Report Date: July 19, 2017 File:1701

Report Number: 057193

Re: An Investigation Referral, Spill Prevention Order MO1701, 460 Stebbings Road, Malahat, BC V0R 2L0 Contaminated Landfill Soil Leachate Collection System, Effluent

Photo 3

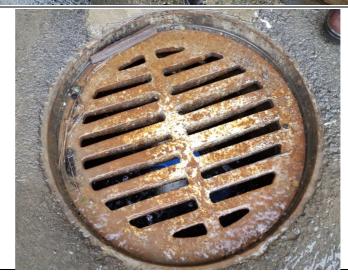
accordance with the Order. During the inspection, the drain at the south side of the SMA was observed to be collecting a significant amount of storm water and Leachate (Photo #/ It was observed that there is a switch that can be turned on and off allowing for discharge the containment pond. The switched was observed to be in the off position as no leachate was discharging to the containment pond through the piping. Compliance: Please ensure that the switch that allows stormwater and Leachate to discharge to the containment pond is left open. This will reduce the risk of the drain overflowing and discharging Leachate into the environment. There is currently an asphalt berm in place at the south side of the SMA, however, the berm has cracked in a few locations which would allow Leachate to release to the ground if a situation arose where the drain overflowed (Photo #2). In order to avoid excess stormwater being sent to the containment pond, consider divertin stormwater away from the drain and the SMA catchment area. 1. c: All works for the collection and temporary storage of Leachate generated at the Facility are inspected regularly and maintained in good working order; and Details/Findings: The landfill cell liner was not maintained in good working order as leachate was observed discharging into the environment via the tear in the landfill cell liner. Compliance: Out Actions to be taken: Please continue to complete regular inspections of the landfill cell liner on-site and patch to the containment and site of the SMA and the south and t	Details/Findings:	Inspection Record #052631 requested that the Leachate be removed from the SMA to the containment pond. The initial volume of Leachate that was located in the Soil Management

Viewing the drain in the SMA close to capacity. Nozzle appears to be in the off position blocking flow to the containment pond.

Actions to be taken: Please ensure that the switch that allows stormwater and Leachate to discharge to the containment pond is left open. This will reduce the risk of the drain overflowing and discharging Leachate into the environment. There is currently an asphalt berm in place at the south side of the SMA, however, the berm has cracked in a few locations which would allow Leachate to release to the ground if a situation arose where the drain overflowed (Photo #2). In order to avoid excess stormwater being sent to the containment pond, consider divertin stormwater away from the drain and the SMA catchment area. Requirement Description: 1. c: All works for the collection and temporary storage of Leachate generated at the Facility are inspected regularly and maintained in good working order; and The landfill cell liner was not maintained in good working order as leachate was observed discharging into the environment via the tear in the landfill cell liner. Compliance: Out Please continue to complete regular inspections of the landfill cell liner on-site and patch to		accordance with the Order. During the inspection, the drain at the south side of the SMA was observed to be collecting a significant amount of storm water and Leachate (Photo #3). It was observed that there is a switch that can be turned on and off allowing for discharge to the containment pond. The switched was observed to be in the off position as no leachate
